**RE: [EXTERNAL]:Fwd: Alrakha-WTRAN-003507: (WF-005827) TERRAZZO-SHOP
DRAWING-ARCH-00282 Rev.01 Building-B Multipurpose Room Flooring Plan &
Elevations**

Document No.	Revision	Title	Status
ARGC-TERRAZZO-SD-ARC-00282	1	Shop Drawing for Building-B Multipurpose Room Flooring Plan & Elevations	For Approval

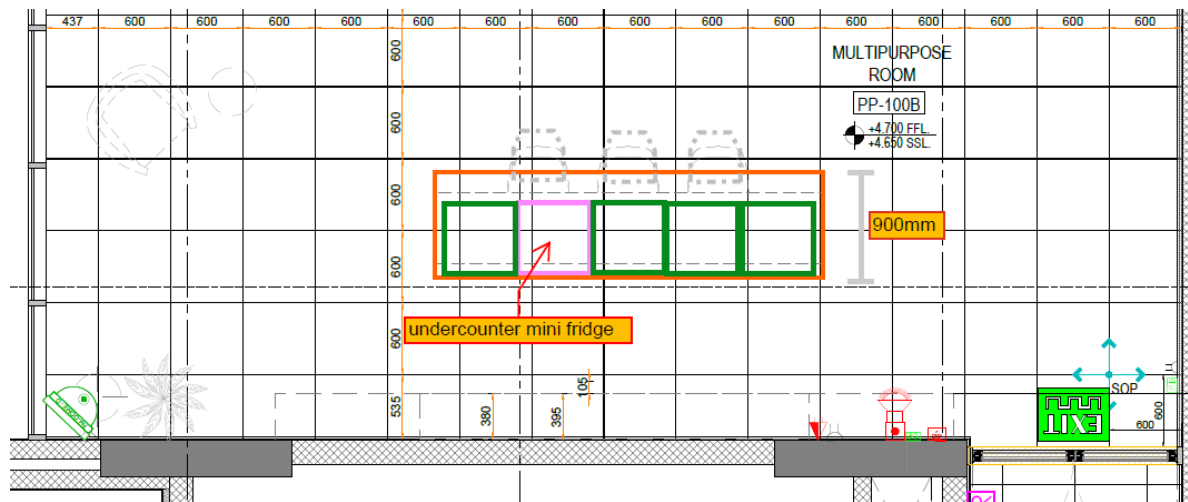
Following up on my previous email, please see Option 2, which involves accommodating the mini fridge on the island counter by increasing its depth from 600mm to 900mm. This provides more flexibility, as otherwise the depth of the joinery on the wall side would need to be almost doubled.
